American General Aircraft Corporation

CRITICAL SERVICE BULLETIN

SB-184

DATE: JULY 10, 1993
SUBJECT: AILERON CONTROL INTERFERENCE
MODEL / SERIALS AFFECTED: AG-5B 99998 and 10000 through 10158
TIME OF COMPLIANCE: Prior to the next flight

FIGURE 1

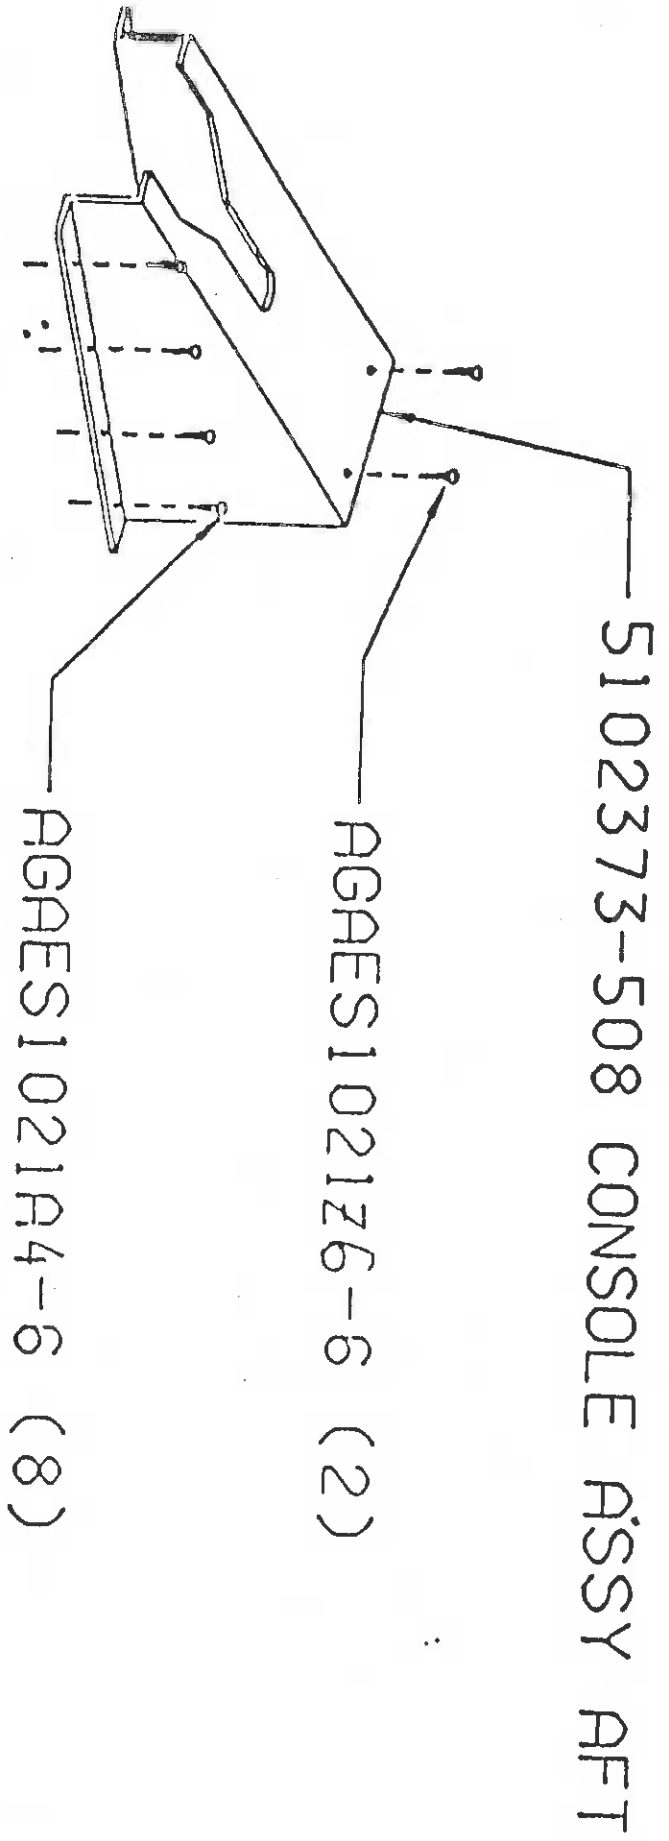
1. Peel back the rear edge of the aft center console carpet so that a minimum of one inch of the top of the metal console can be seen.
2. Check for the installation of two (2) AGAES1021Z6-6 screws which secure the 5102373-508 console to the rear seat forward bulkhead. (FIGURE 1)

1. Remove the eight (8) AGAES1021A4-6 retaining screws (FIGURE 1) and remove the aft center console.

FIGURE 2

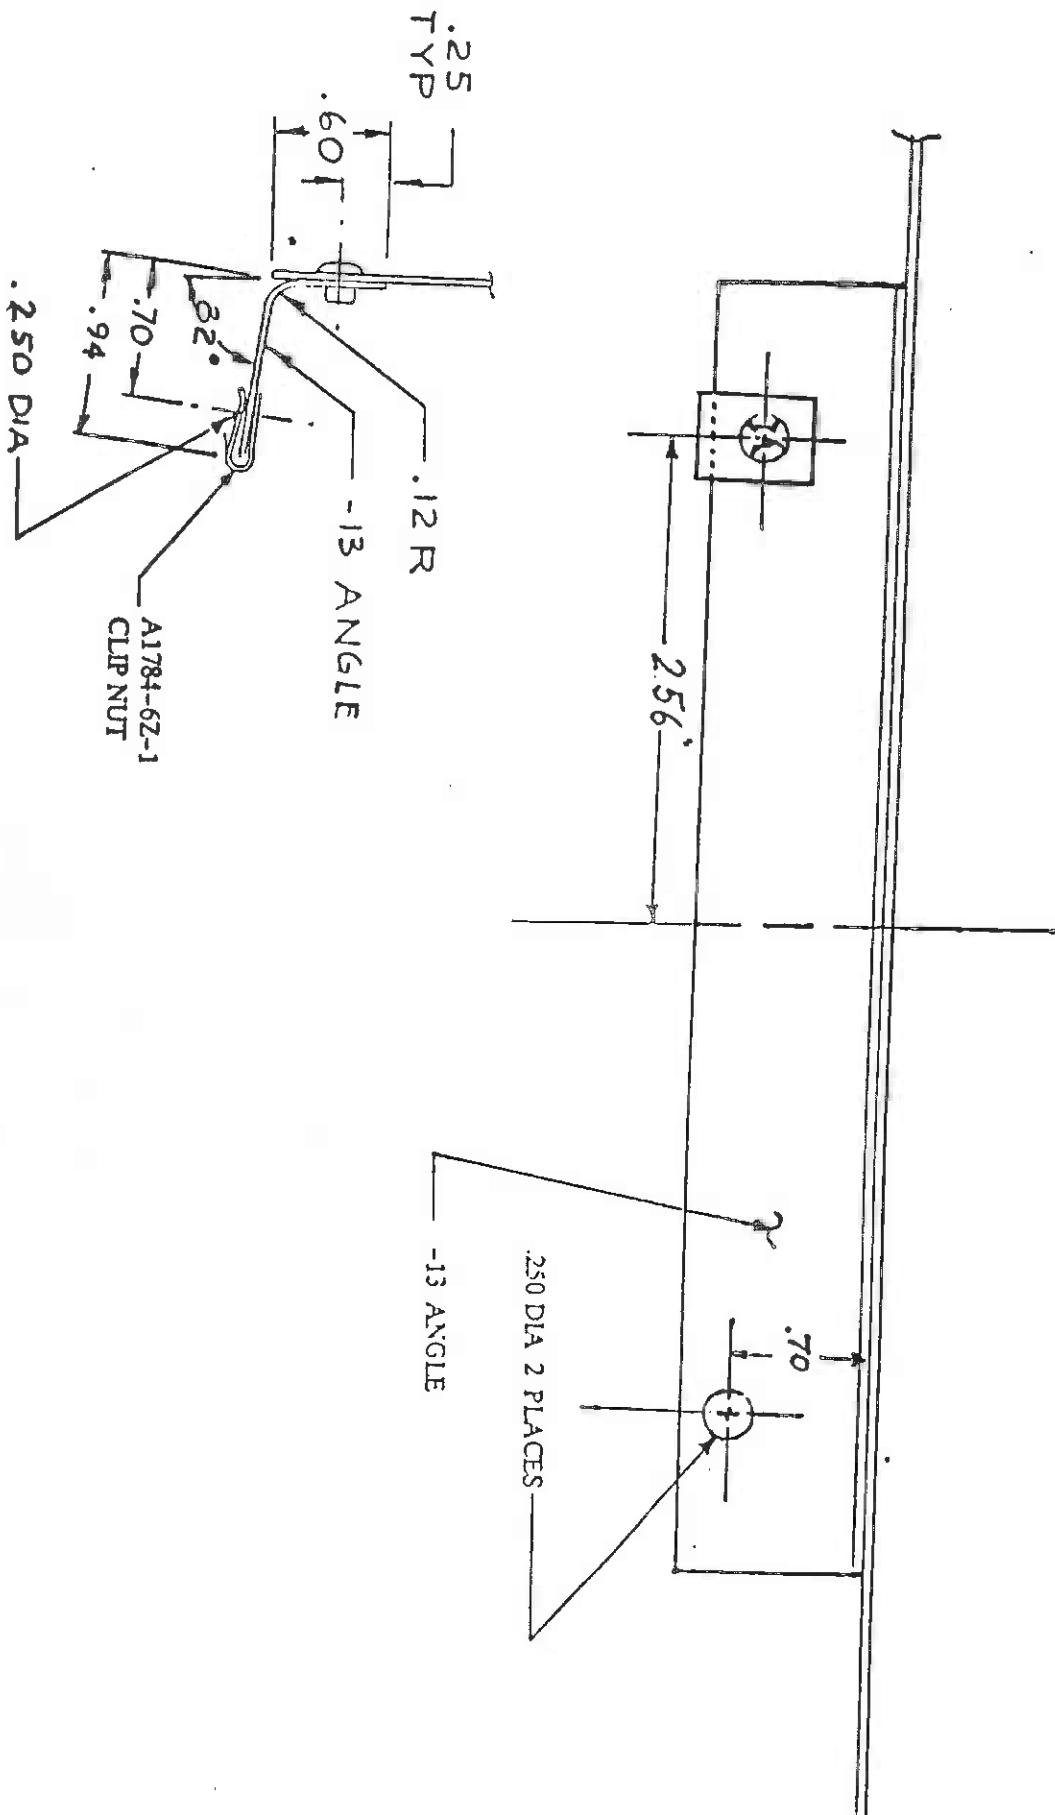
2. Locate the -13 angle on the forward rear seat bulkhead. (FIGURE 2)

There may be holes with clip nuts installed on the -13 angle. If the holes are located per the drawing in FIGURE 2, proceed with step (4). If the holes are not in the proper location, remove the clip nuts and proceed with step (3).

3. Locate and drill (2) 0.250 inch diameter holes in the -13 angle per the FIGURE 2 drawing and install (2) A1784-6Z-1 clip nuts.
4. Position the -508 console assembly in place and using a #26 drill bit, match drill (2) 0.147 inch diameter holes in the console to align with the holes in the -13 angle.
5. Secure the -508 console to the -13 angle using (2) AGAES1021Z6-6 screws and to the floor using the previously removed (8) AGAES1021A4-6 screws.
6. Re-secure any carpet removed for access.
7. Record compliance in the aircraft log book and return the aircraft to service.
8. Complete the attached compliance card and mail to:
